CanWhite Sands – Silica Sand Extraction Project Environment Act Proposal –

File No. 6119.00

Public Comments Received From

**Questions for CanWhite Virtual Open House for the Vivian Sand Extraction Project
and Hydrogeological Report**
by D.M. LeNeveu B.Sc. (hons. physics) M.Sc. (biophysics) B.Ed.
Aug. 20, 2021

Figure 1. Limestone thickness in the carbonate aquifer of the CWS BRU extraction area.

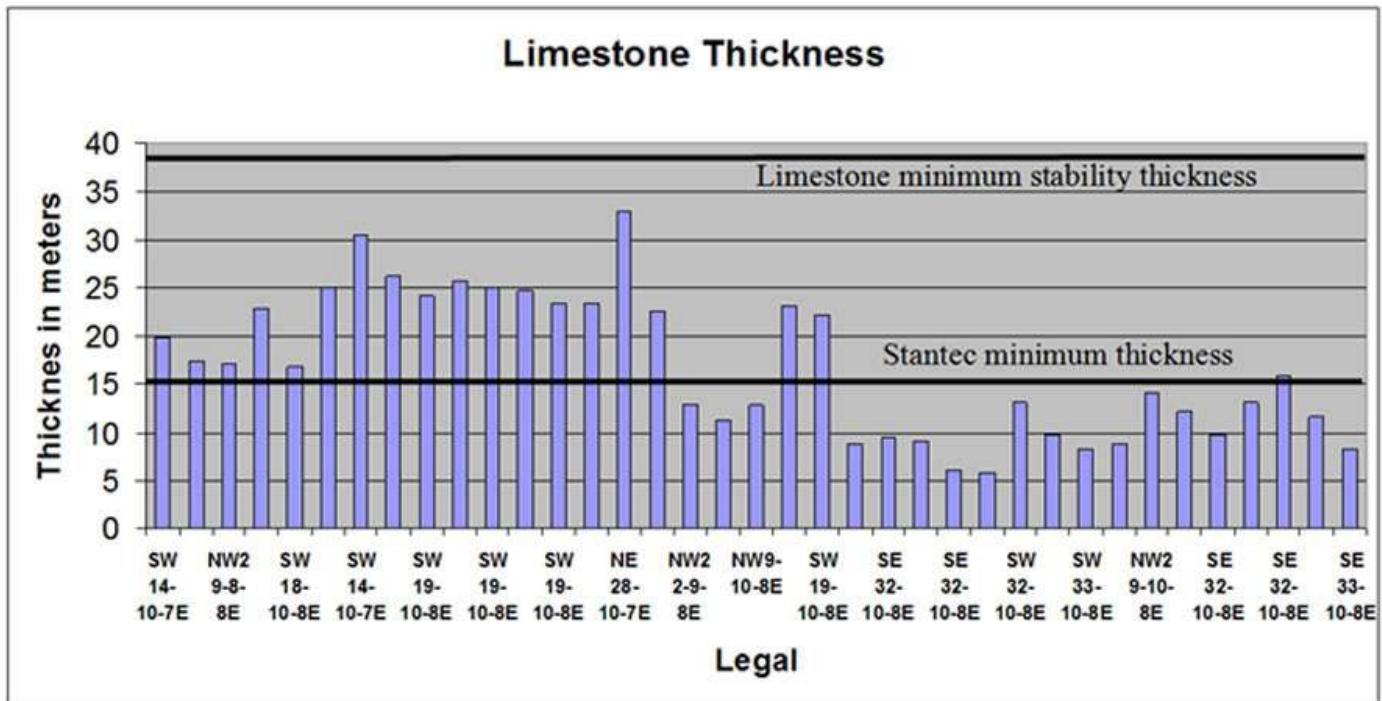
A peer reviewed paper by Waltham and P. Fookes specifies that minimum stability thickness for limestone above a cavity must be 70% of the cavity opening dimension excluding overburden cover.¹ For the CWS standard design opening for a seven well extraction cluster the limestone thickness must be at least 37.8 m. The limestone of the carbonate aquifer in the Bru extraction area has a thick overburden cover of glacial till whose unsupported weight will increase the minimum stability thickness for the limestone.

Figure 1 shows the limestone thickness of the carbonate aquifer in the Bru extraction area and the Stantec and Waltham and Fookes thickness limits. The data was taken from CWS well records supplied by Manitoba Groundwater and from the CWS borehole records in the hydrogeological report. The well records demonstrate that over the entire Bru extraction area all limestone thicknesses are less than the minimum criteria stated by Waltham and Fookes for stability. All limestone thicknesses in the eastern Bru area where extraction activities will begin are less than the Stantec limit of 15 meters. The limestone thickness in general increases westward.¹³

Question:

Will CWS move their operations westward into the ALY area where the limestone is thicker and the sandstone aquifer is saline to avoid subsidence?

Figure 2. Cover collapse sinkholes from USGS.³

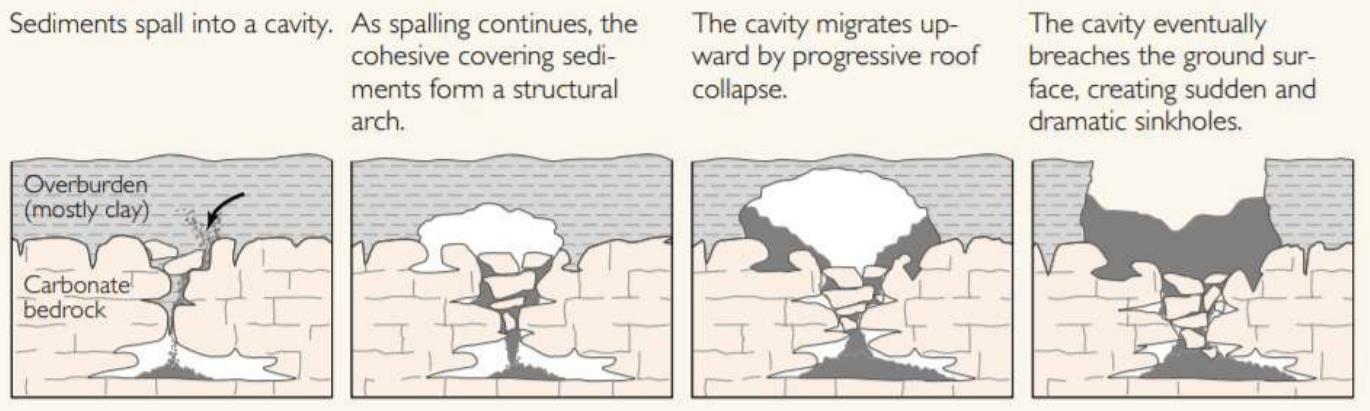
The glacial till overburden will gradually migrate into the cavity through the compromised limestone layer causing a cover collapse condition. In cover collapse subsidence the cavity created in the till overburden by gradual migration through the limestone layer will suddenly collapse at some undetermined time in the future leaving a large sinkhole as illustrated in Figures 2 and 3. All of the well clusters created by CWS operations are susceptible to cover collapse. A moonscape of water filled sinkholes will be eventually created. Water contaminated iron bacteria, fecal coliform from septic fields and animal feces, other microbes, and chemicals from surface runoff will have direct access to the carbonate aquifer and the sandstone through the compromised shale aquitard. This subsidence scenario is untenable.

Figure 3. Sinkhole development from CWS sand extraction²

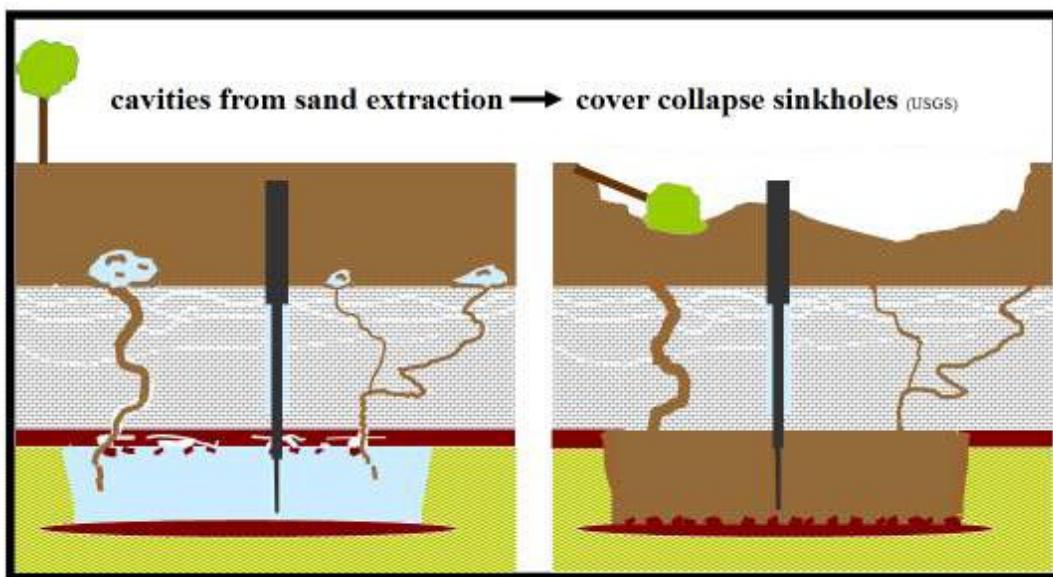
A report released by What the Frack Manitoba in February 2021, peer reviewed by A. Ingraffea of Cornell University a world renowned expert on geo-mechanics, determines the shale aquitard will be unstable and slake into the cavity from the sand extraction.²

Figure 4. CWS 24 year project area overlaid on the map of the extent of the Carman sands (green speckled area) south of Vivian MB.

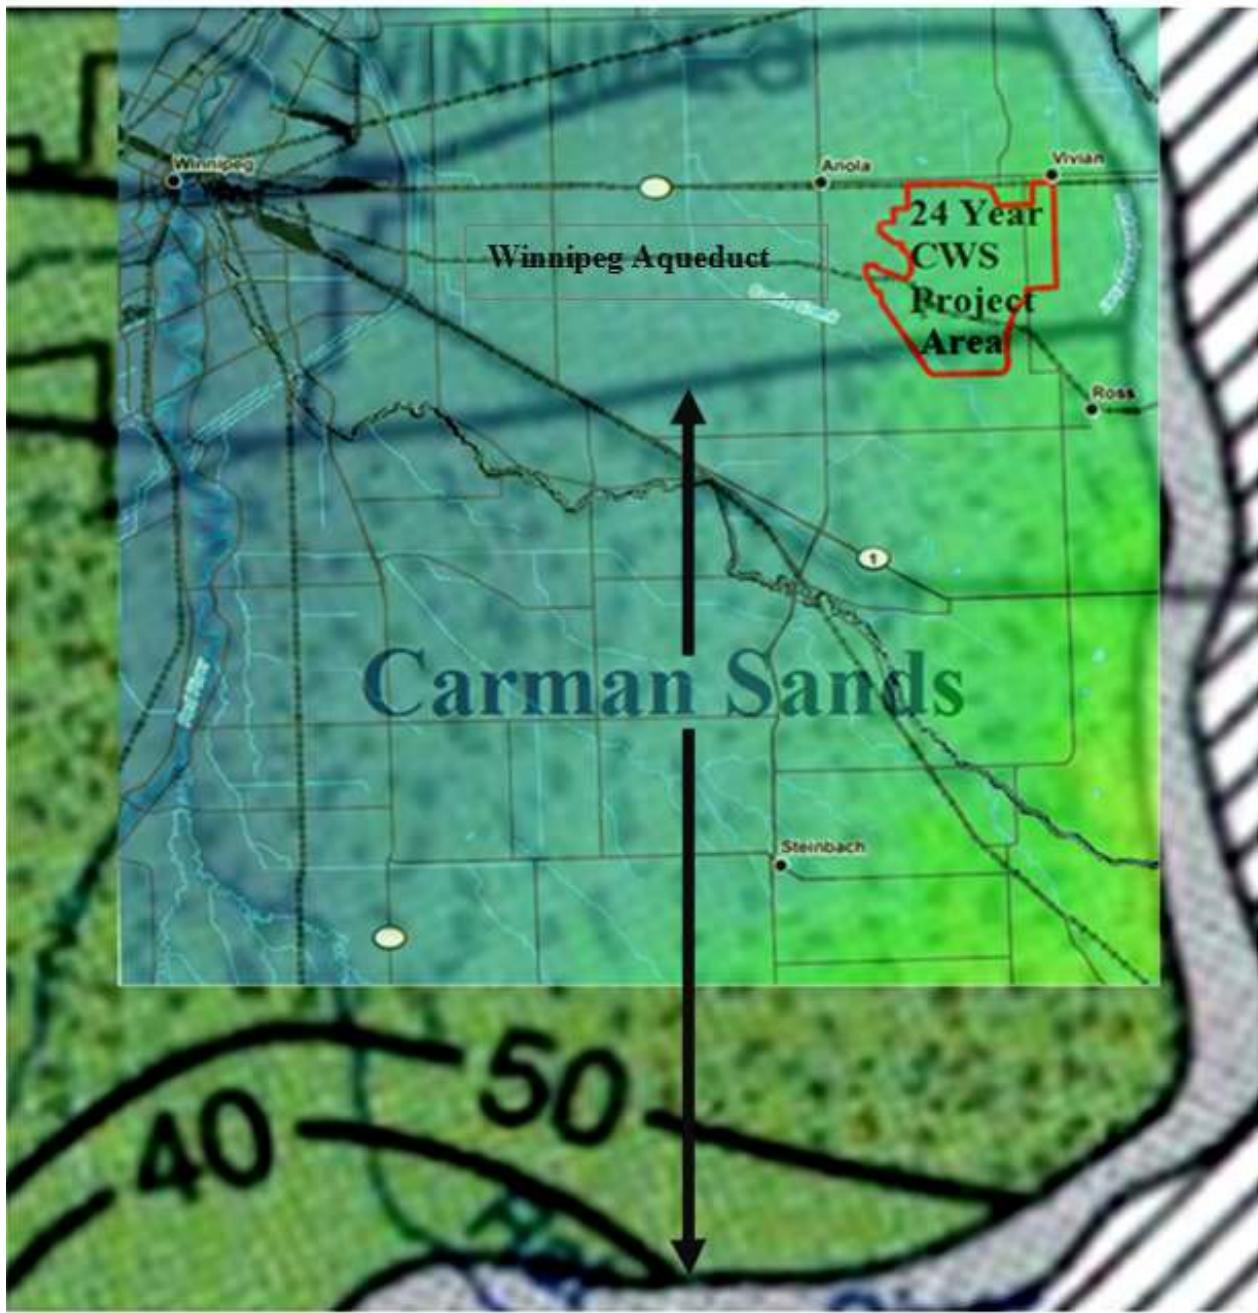
The above quote states the Carman Sands are below the Sandilands area. Figure 4 shows the Carman Sands as determined from the Manitoba Energy and Mines Bedrock Geology Compilation Map Series¹³ overlaid on the CWS 24 year Project area. Figure 4 clearly shows only very southern portion of the project area is within the Carman sands.

Thus even the lower portion of the Carman Sands in the southern portion of the claim area is interbedded with shale that is likely rich in pyrite.

Does CWS acknowledge the northern part of the BRU project area is wholly within the Black Island member part of the Winnipeg formation known to contain pyritic shale, marcasite coating the sand, pyritic concretions such as oolite layers and not within the Carman sands area?^{10,12,14,15} Does CWS acknowledge that the Black Island member from which sand will be extracted in the northern portion of the Bru area contains pyrite that will be exposed to re-injected aerated water that will from acid and mobilize heavy metals and selenium thereby contaminating the aquifer?

As illustrated in figure 4 the Winnipeg aqueduct traverses the entire 24 year CWS project area. The slurry lines will eventually have to cross the aqueduct likely multiple times. The aqueduct is known to have cracks

Has CWS informed the City of Winnipeg of the requirement of the slurry lines to cross the Winnipeg Aqueduct and described safeguards that will mitigate the potential for contamination of the aqueduct water? Has CWS obtained a legal agreement with the City of Winnipeg and the Government of Canada to cross the aqueduct considering that the aqueduct crosses provincial boundaries and is therefore federal in scope?
